BOA GENERAL REVIEW COVERSHEET

CASE: C15-2023-0034**BOA DATE:** December 11th, 2023**ADDRESS:** 5111 Lansing Dr**COUNCIL DISTRICT:** 3**OWNER:** Margarita Renee Suaste**AGENT:** N/A**ZONING:** SF-3-NP (South Manchaca NP)**LEGAL DESCRIPTION:** LOT 12 BLK F EMERALD FOREST SEC 5

Master Comment Report

Property: 5111 LANSING DR

Plot Plan

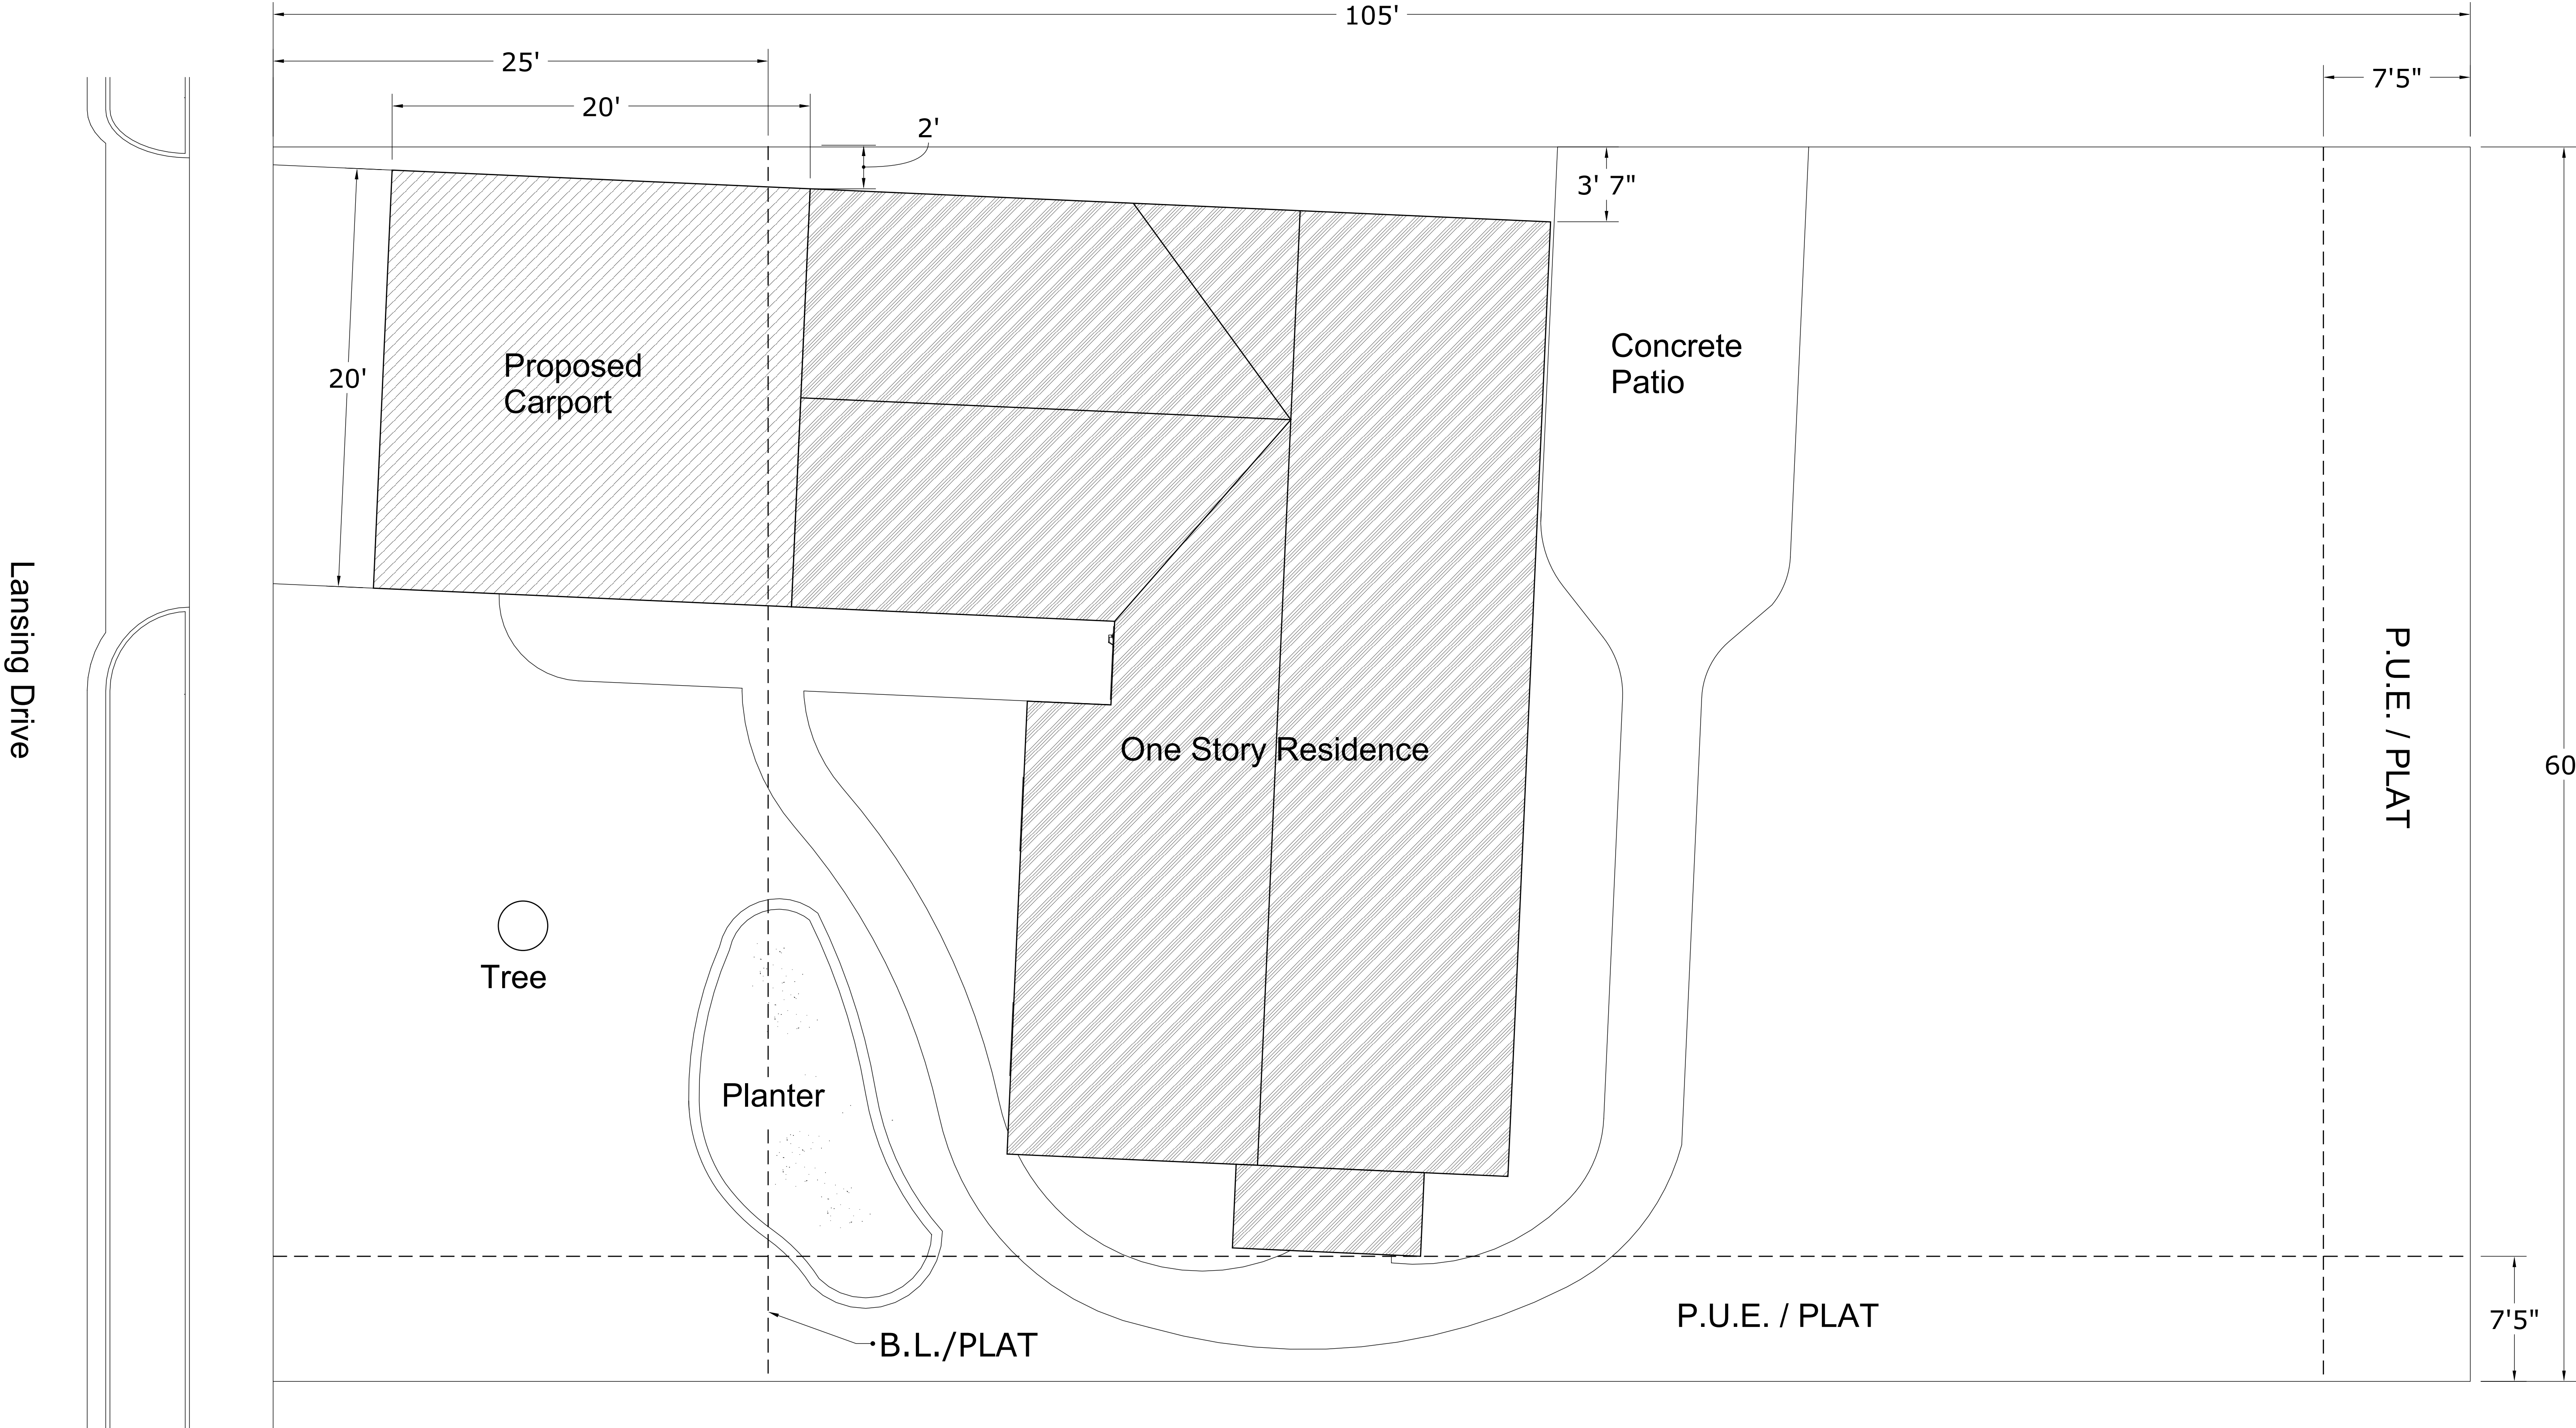
RZ.5 - Site Plan/Plot Plan

Plot plans must be drawn to a standard scale and are to include but are not limited to the following items: property address and legal description, north arrow, drawing scale, trees within the ROW or trees equal to or greater than 19 inches in diameter located on the property and immediately adjacent to the property, property lines, building lines for both existing and proposed improvements, easements, **required zoning setbacks** and roof overhangs, water meter and wastewater cleanout locations, underground and overhead utility lines and appurtenances, and water and/or wastewater line size and material.

1. Please update the site plan to display the **bolded** information provided above. Zoning Setbacks can be found using the [§ 25-2-492 - Site Development Table](#)

RZ.6 - Impervious Cover and Parking Placement Restrictions

1. Please update the site plan to show the front yard impervious cover percentage.

TOR Comment #1: Properly represent to scale and label the Quarter, Half, and Full Critical Root Zones (CRZs) of all protected trees (19 inch or greater diameter) on the Site Plan and Foundation Plan if any CRZs overlap the proposed foundation.

- Show the 36-inch live oak's Full, Half and Quarter CRZ to scale.
- Show the Quarter CRZ of the tree in the left neighbor's front yard.

TOR Comment #2: Accurately identify the species (ex. Live Oak, Post Oak, Cedar Elm, American Elm, etc. - not just Oak or Elm or Tree).

- The tree listed as a hackberry is a Chinese tallow.

TOR Comment #3: Tree protection fencing (5-foot chain-link fence) should be extended to the Full available Critical Root Zone (CRZ) of all Protected trees (19-inches or greater in diameter). Fencing is the primary method of tree protection. Any area of the Full Critical Root Zone that is not fenced will be allocated 8 inches of natural wood mulch. Decking (plywood or similar) is required when mulch is used within the Half Critical Root Zone and is not protected by fencing. Install trunk wrap (2x4 lumber) whenever protective fencing is 5 feet or less from the trunk of the tree. Please depict both the fencing and mulch clearly on the plans. [Reference the Environmental Criteria Manual 3.6.1 – Tree Protection Requirements for more information.](#)

- Tree protection fencing must be continuous and create a closed, inaccessible area of root zone protection. Please expand the fencing for the 36-inch live oak. Show tree protection mulch in any area of the CRZ that cannot be fenced for the Chinese tallow and live oak.
- Show tree protection directly on the site plan (ex: fencing as a red line, shaded areas for mulch). A note will not suffice for the depictions.
